Application for Variation of an Environmental Permit

C2. Application No. of the Current Environmental Permit : AEP-393/2010

**Agreement No. CE 6/2015 (EP)
West New Territories (WENT)
Landfill Extension – Design and
Construction**

Supporting Document for Variation
of Environmental Permit

**GENERAL PLAN
OF ENHANCED SCHEME**

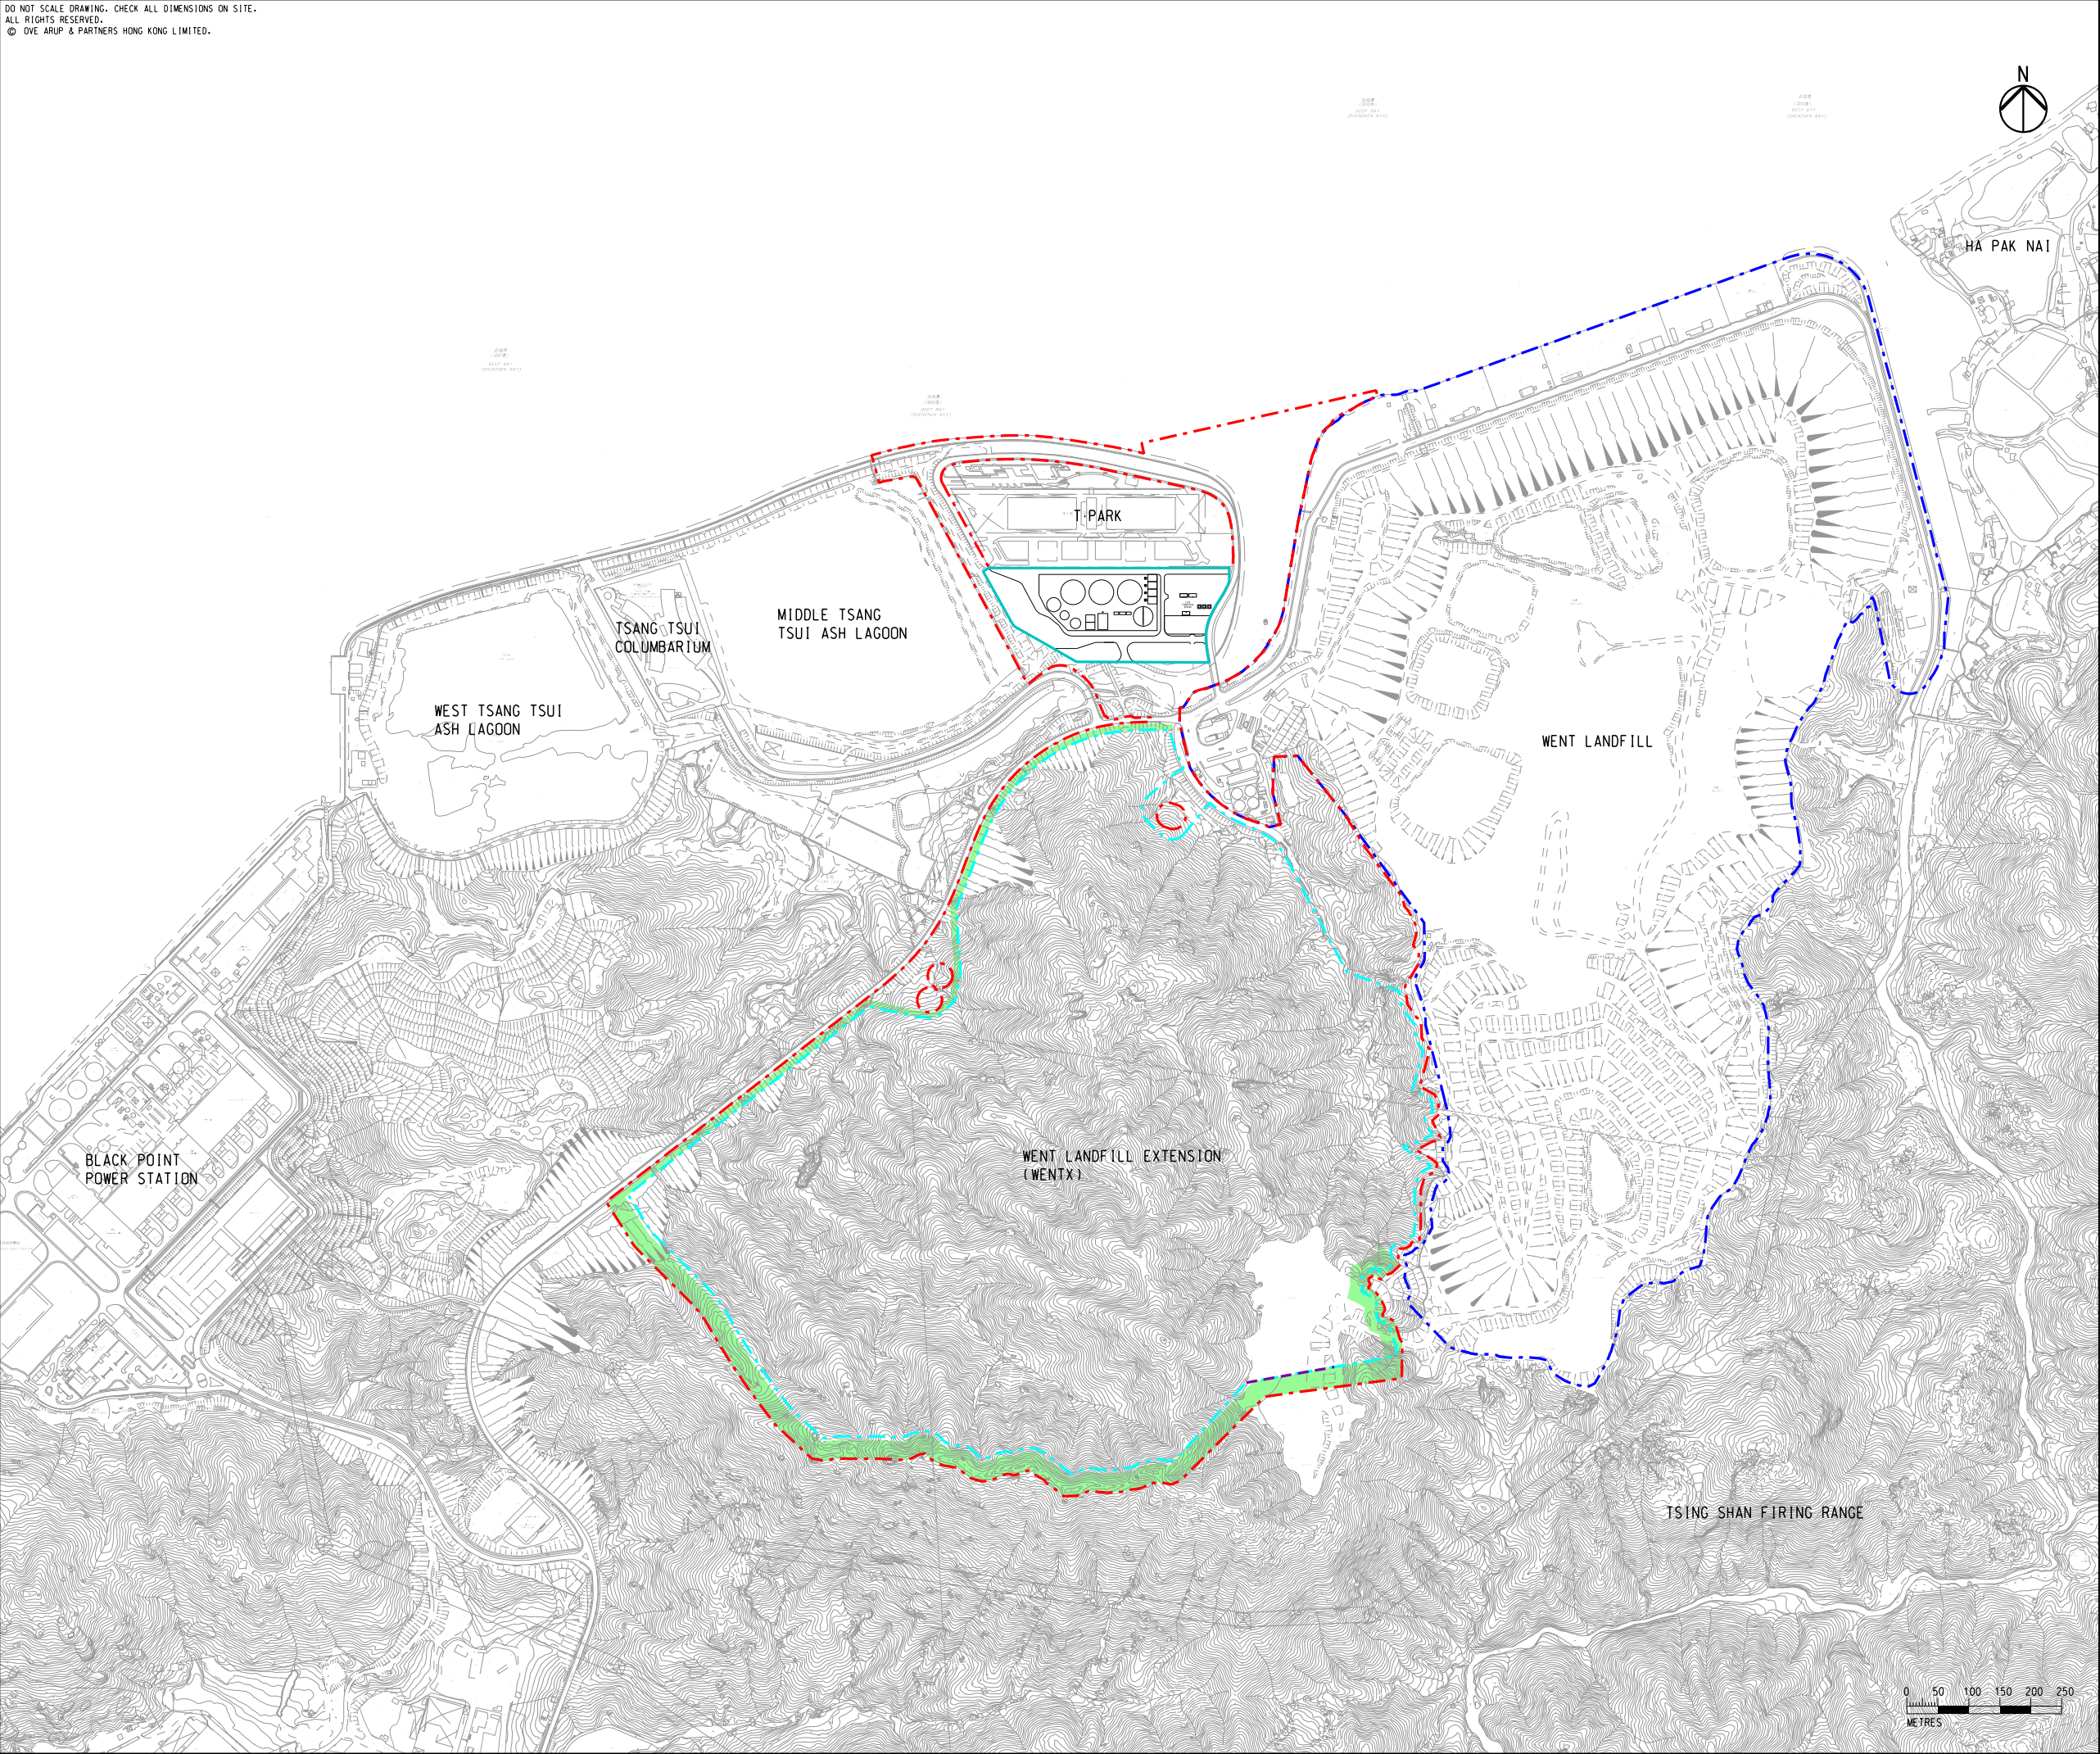
1.1.3 In considerations of the above, the reference design and implementation programme for the WENTX (hereby referred to the Enhanced Scheme) has been revised. The major design changes and revised layout design are shown in **Table 1.1** and **Figure 1.2** respectively.

Drawing title
**PHASING OF LANDFILL CELLS
IN ENHANCED SCHEME**

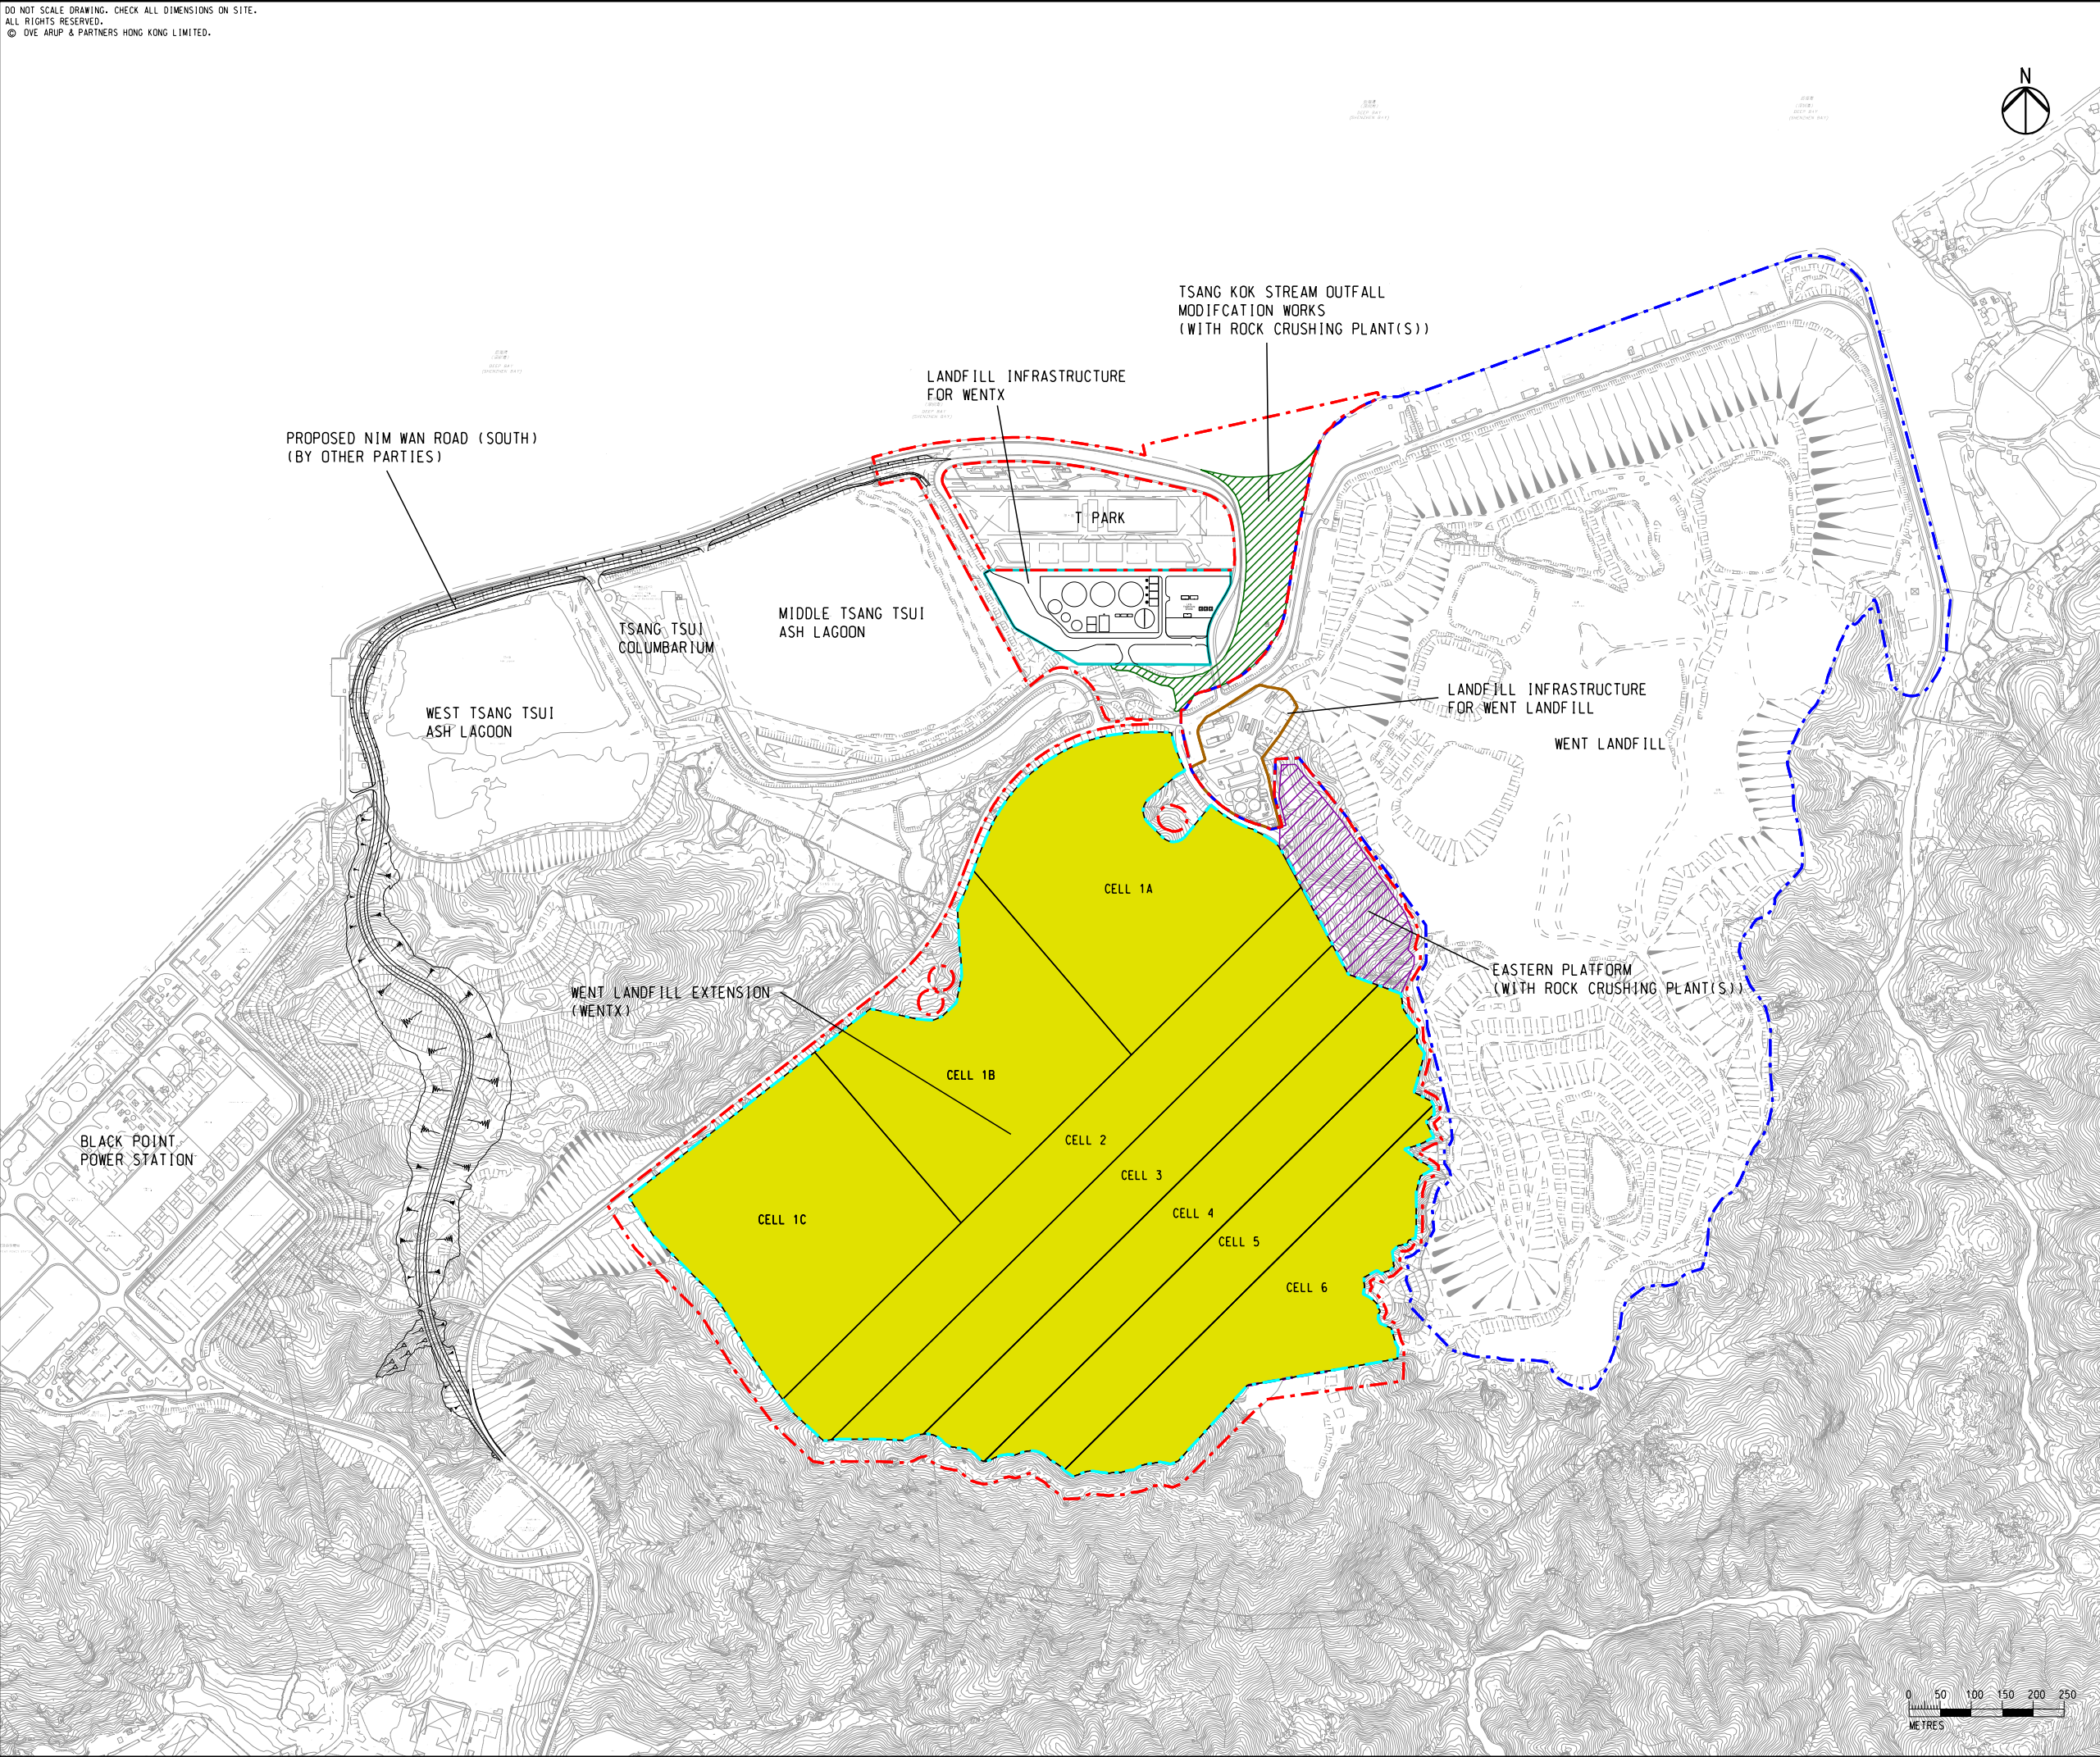
- 2.2.4** In the Original Scheme, the WENTX would be developed in phases, generally from the east to the west of the site in a clockwise direction, as shown in **Figure 2.1**. In the Enhanced Scheme, the WENTX would also be developed in phases, but generally from north near the Nim Wan Road to the south, as shown in the tentative outline phasing programme in **Figure 2.2**. In view of the design-build-operate nature of the WENTX project, the WENTX contractor will, upon contract award, prepare its own landfill development phasing plan to suit the actual site development programme, plants and resources availability, method of works, etc. The outline landfill phasing programme is only indicative and for reference use.
